A12 Chelmsford to A120 widening scheme

TR010060

9.78 Applicant's Comments on Information received at Deadline 7

July 2023

Appendix A – Figure 1 for REP7-068-002

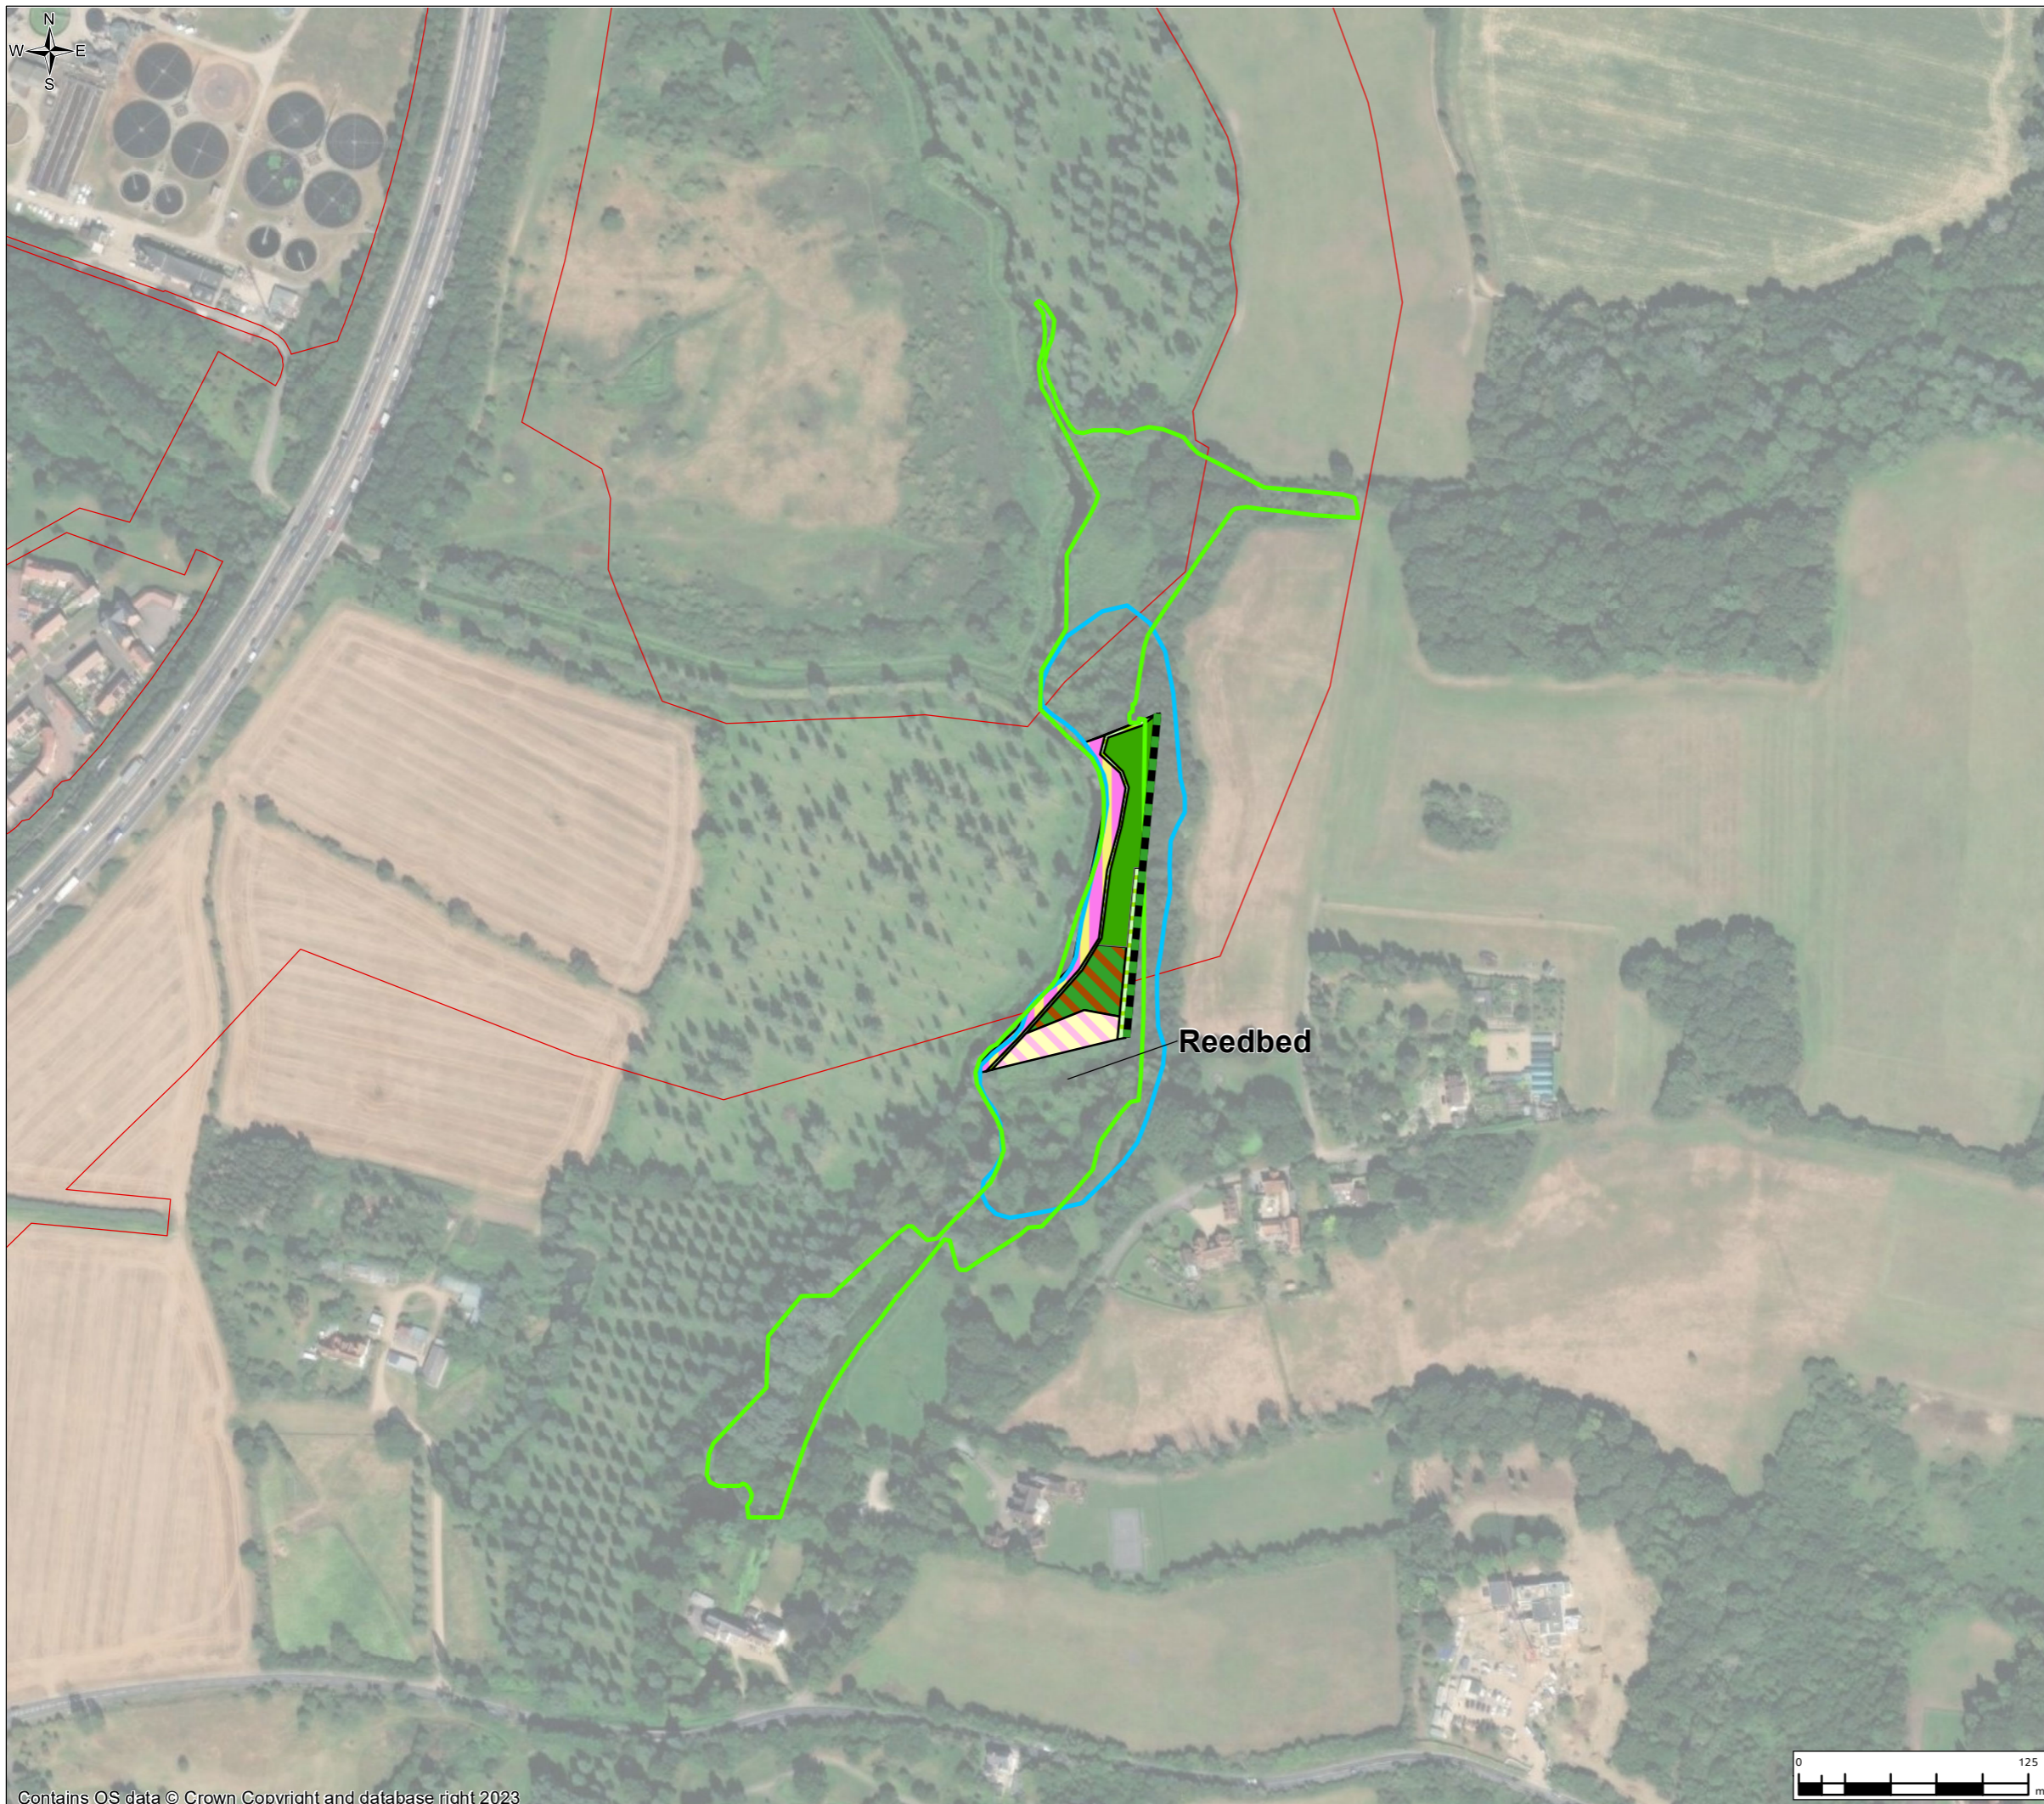
The Applicant acknowledges the text within the Blue Mills proposed LWS citation which describes 'a central area of reedbed', however the citation is describing the entire LWS which extends south of the Order Limits (see Appendix A - Figure 1 of this document) and therefore what is described as 'central' means central to the entire proposed LWS, not central to the part of the proposed LWS which sits within the Order Limits. As shown on Figure 1 of the Supplementary Botanical Report [REP2-027] (and also shown of Appendix A - Figure 1 of this response) and as explained on page 64 of the Written Submission of Oral Case for ISH5 [REP7-043], there is no reedbed within the Order Limits. The area of reedbed is located east of the bend in the River Blackwater (as indicated on Appendix A - Figure 1 of this document). This is consistent with Figure 1 of the Supplementary Botanical Report [REP2-027], i.e., it is south (and outside) of the Order Limits.

The Applicant would also like to draw Mr Cathcart's attention to Figure 1 in Appendix A of this document which presents the correct boundary of the Blue Mills proposed LWS. This figure supersedes Figure 1 as provided in the Applicant's Comments on Information Received at Deadline 5 [REP6-090] within which the boundary of the LWS was incorrectly shown.
